MEMORANDUM FOR MILITARY/INDUSTRY DISTRIBUTION

SUBJECT: EP Study to determine if the "F" measurement of Figure 313-1, Interface, Series TNC, pin contact, should be removed or modified to a minimum of "0.00" from "0.06". Project number 5935-2019-010.

Dim. Ltr.	Inches (mm)	
	Min.	Max.
...	...	
F	.006 (0.15)	-----
...	...	...

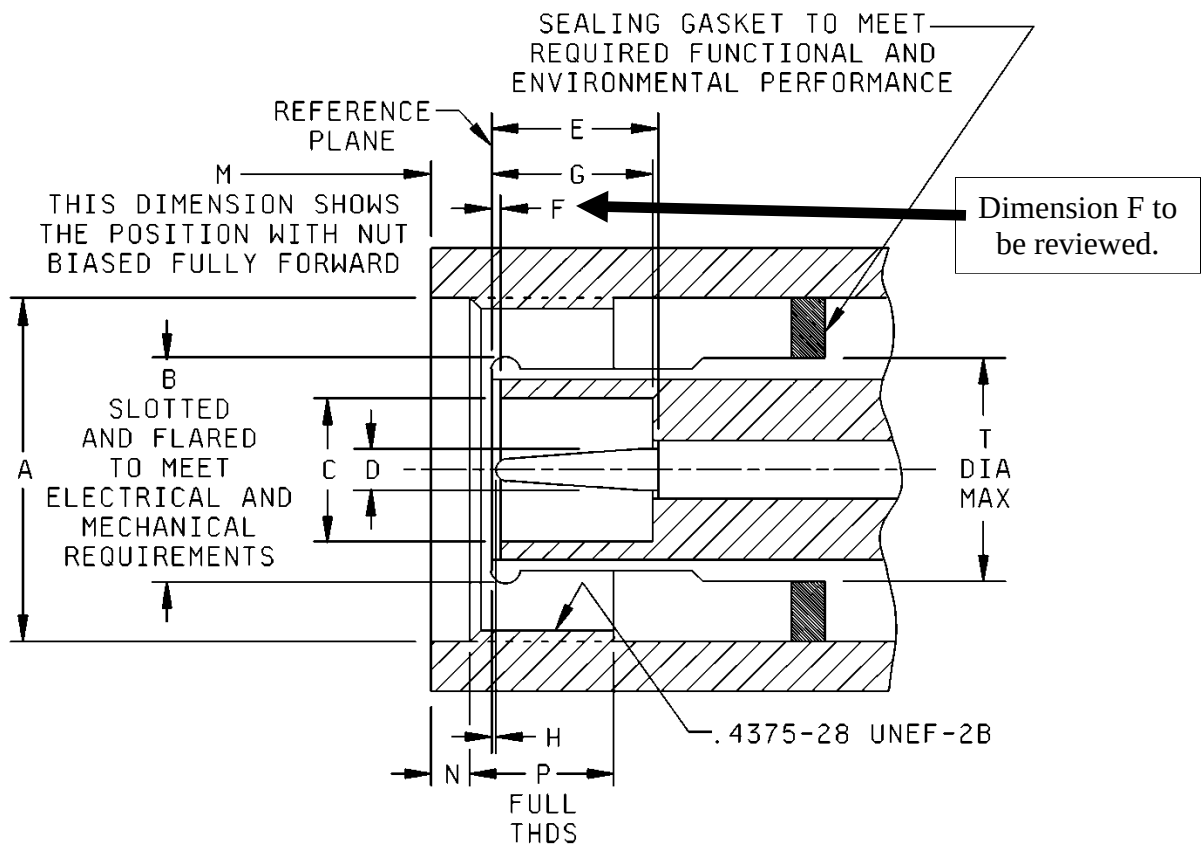
The purpose of this EPS is to determine the F dimension outcome for Figure 313-1.

Question #1. MIL-STD-348B, Change 3 incorporates dimension F measurements into the TNC Series Interface in Figure 313-1.

- 1) Should dimension F be reduced from 0.006 to 0.00? (See above figure and truncated table).
- 2) Should dimension F be removed completely, allowing for a complete re-label of Figure 313-1?
